Nov 2020

Issue to resolve

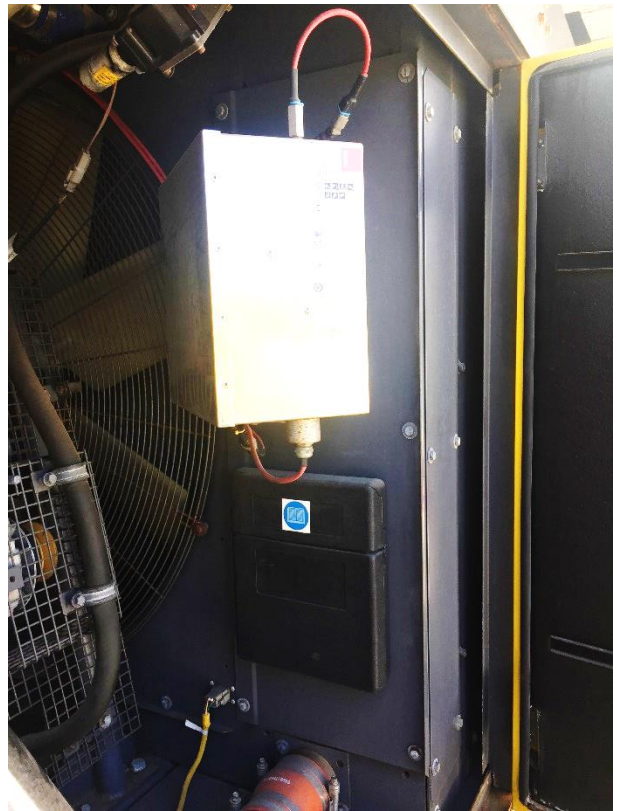
- Resolve mounting location for FP Unit – not as per drawing
- Resolve Mounting Location for Panel – not as per drawing
